**AGENDA
TECHNICAL REVIEW COMMITTEE
REGULAR MEETING
AUGUST 13, 2020
9:00 AM
CITY HALL COMMISSION CHAMBERS
204 ASH STREET
FERNANDINA BEACH, FL 32034**

- 6. NEW BUSINESS**
- 7. OLD BUSINESS**
 - 7.1 SPR 2018-07 Mocama Brewery: Trey Dennard with Dreamscapes - Proposed Landscape Plan Revisions
 - 7.2 SPR 2019-11 Bistro 2020: Wayne Chism with Chism Development Company to discuss 2nd round of review comments.

REVISED LANDSCAPE PLAN

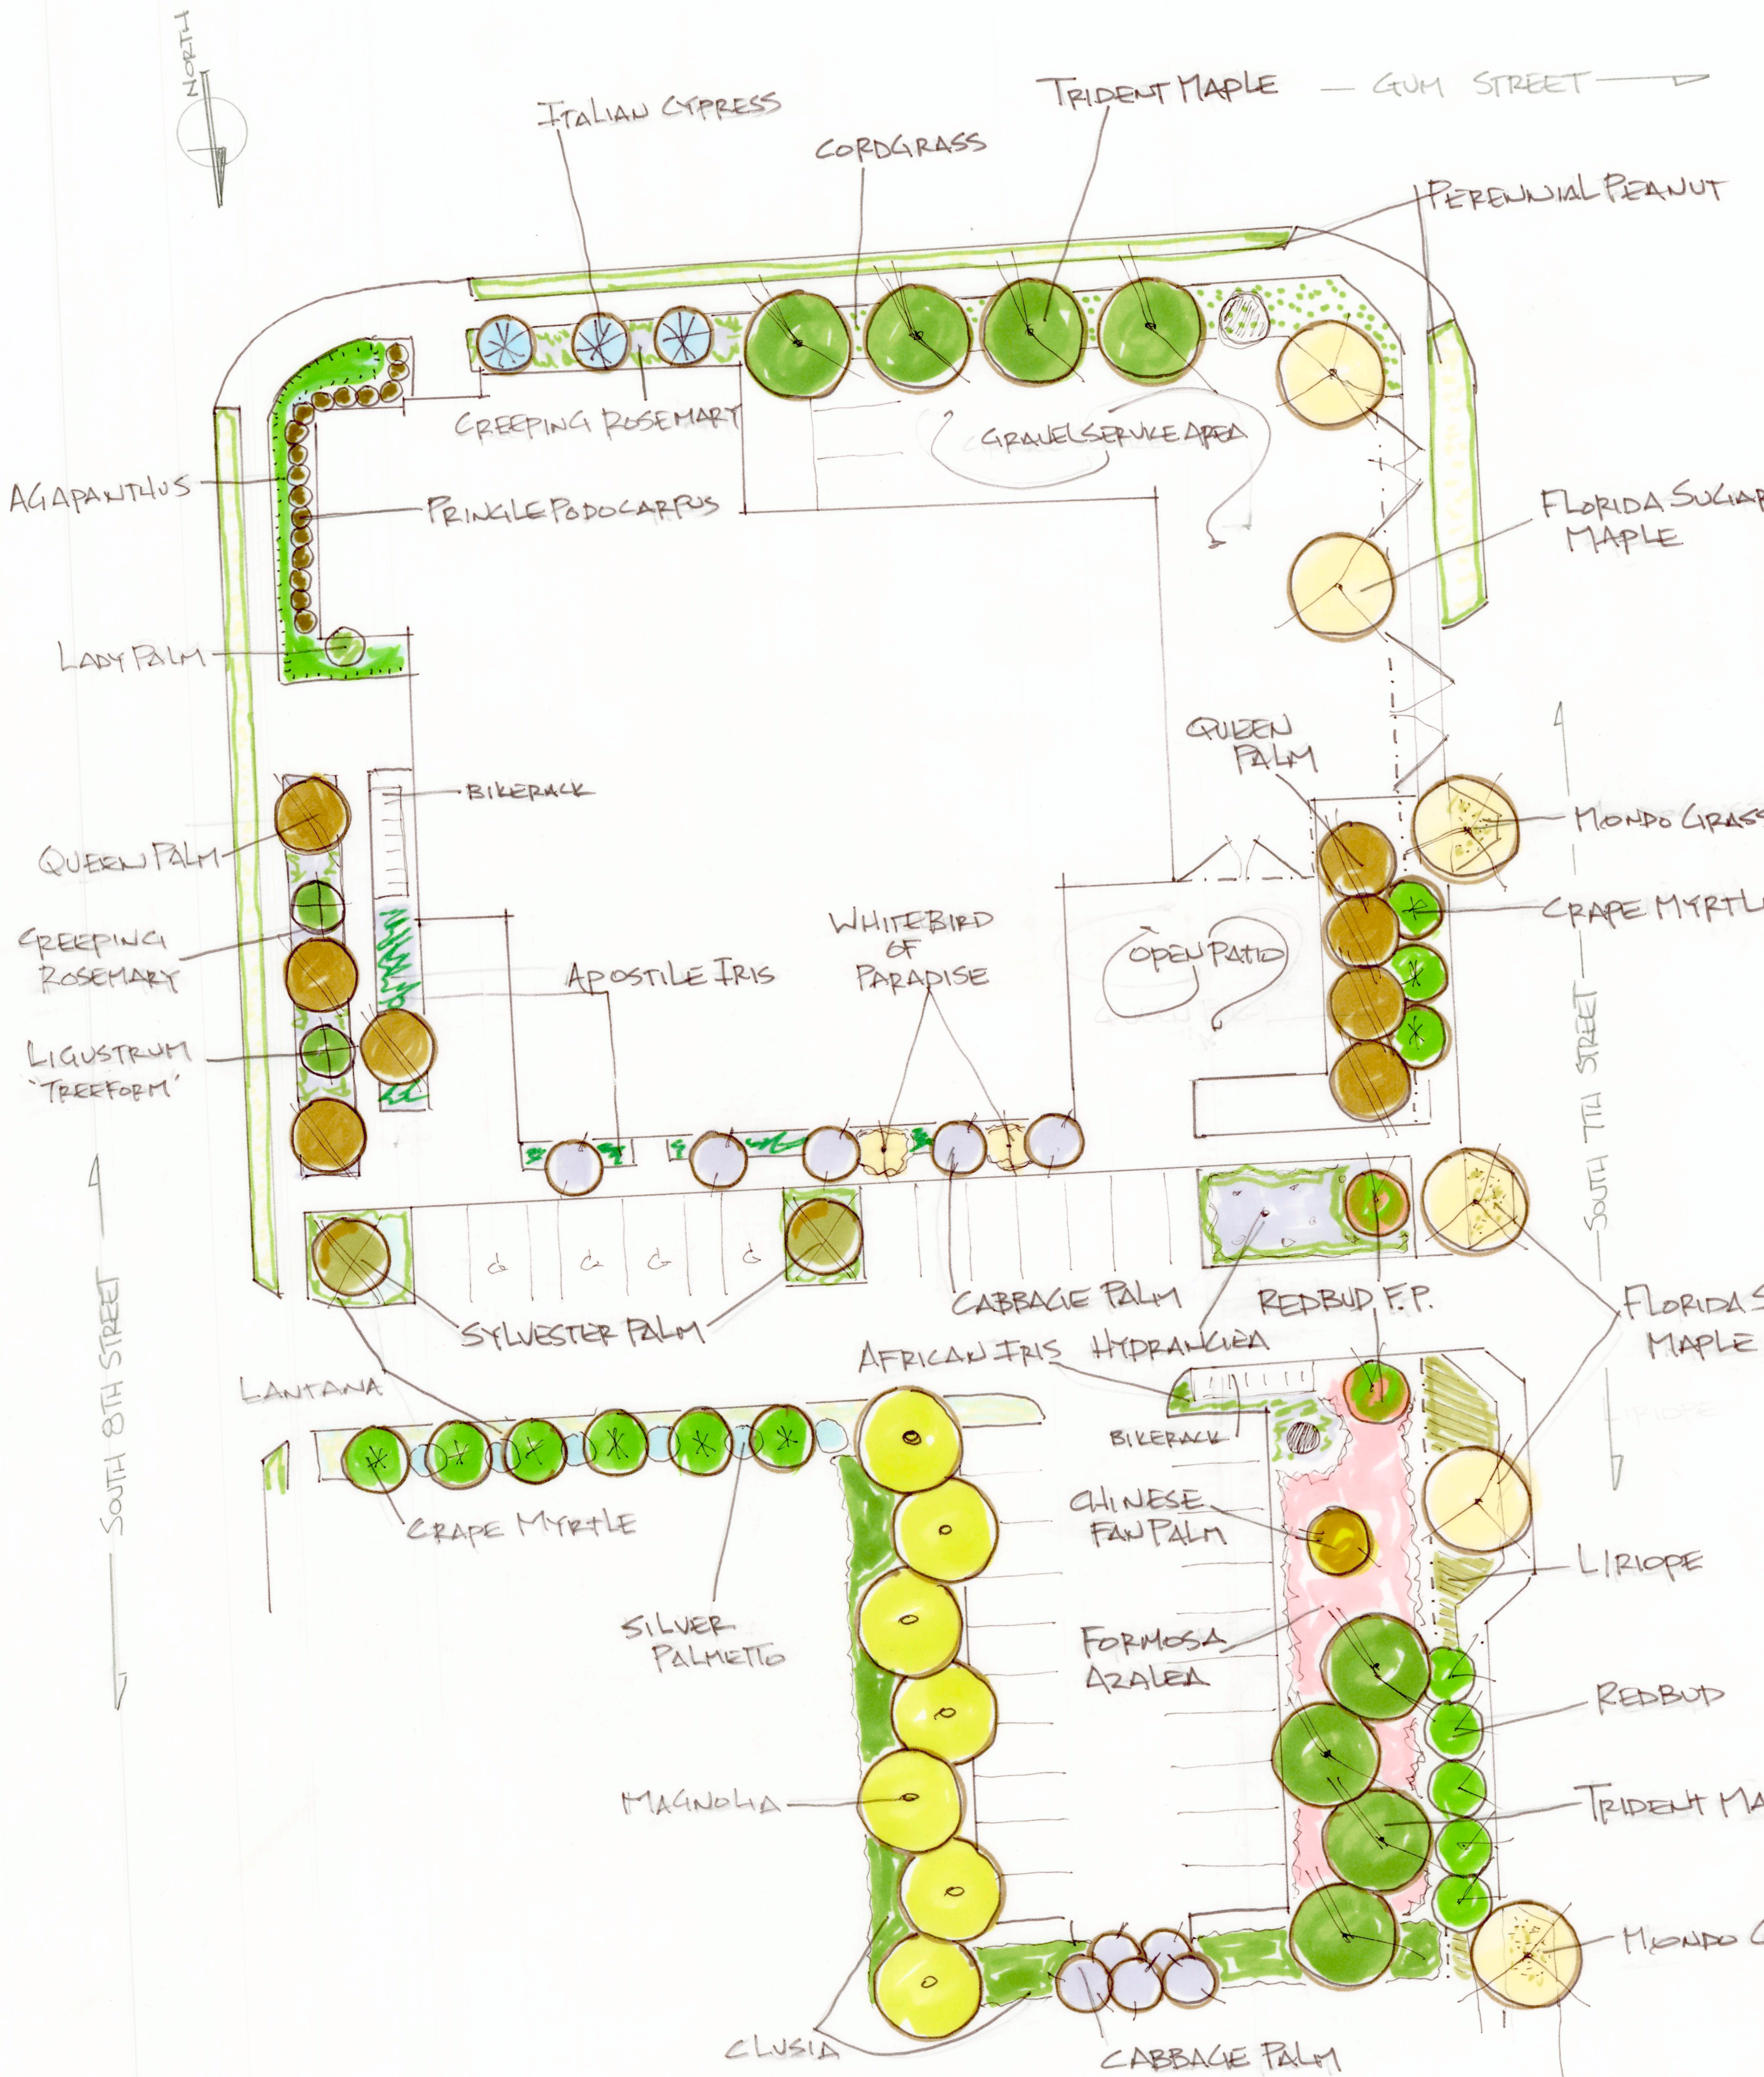
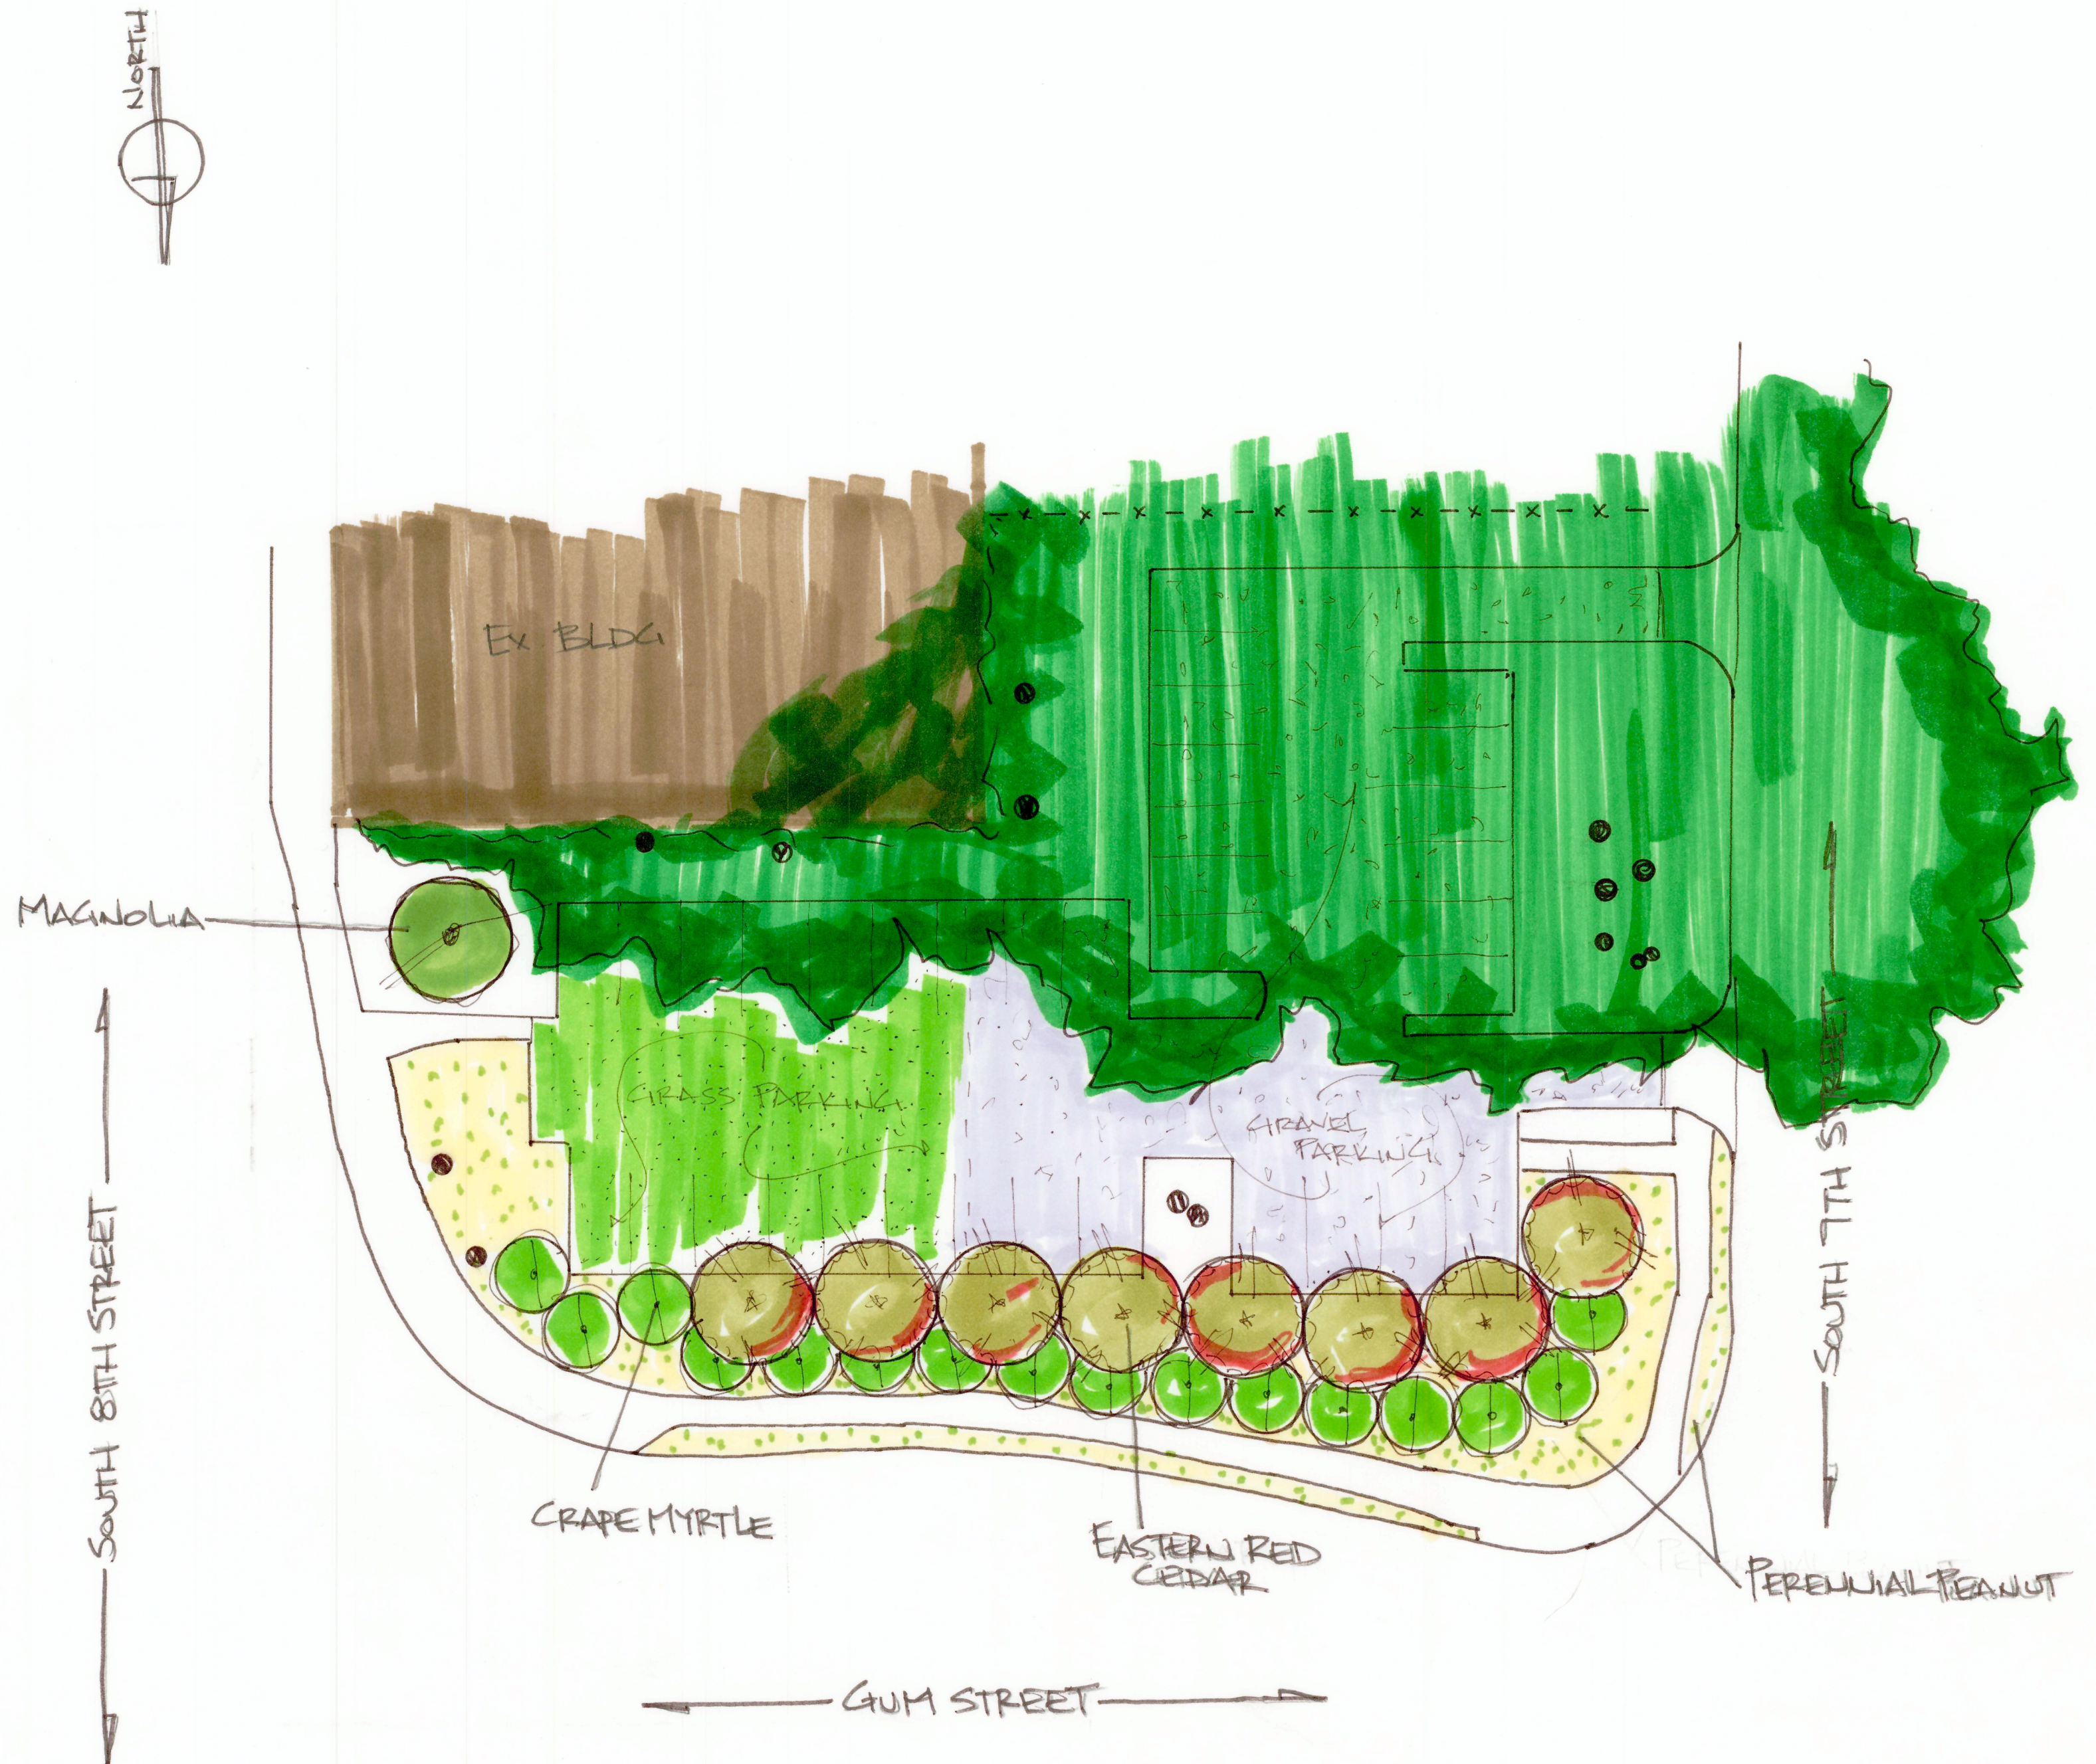
- Sheet S-2 states that the proposed curb and sidewalk are to match the existing conditions.
- The Summary Block on sheet S-1 states that the total square footage of non-residential use is 5,732 SF. The proposed building coverage is 3,816 SF. The proposed FAR is 5,132 SF where 8,500 is permitted.

- Sheet S-1 calls for a 60" tall screening around the trash area.

- Within the Summary Block on sheet S-1, the ground floor is required to have fire suppression and the 2nd floor with Use "B" is not required to have fire suppression. The structural plans for both the ground and second floor to have 1HR fire rated exterior walls.

- Clarify if project will fall under SJRWMD or FDEP Environmental Resource Permit thresholds or provide the necessary permit.
- Sheet S-1 notes that impervious coverage may be 100% “where stormwater facilities are available and have sufficient capacity to accept runoff from the lot”. No calculations have been provided regarding runoff or sufficient capacity of the stormwater facilities. This needs to be clarified. This does not satisfy the requirements of LDC 3.05.03F.
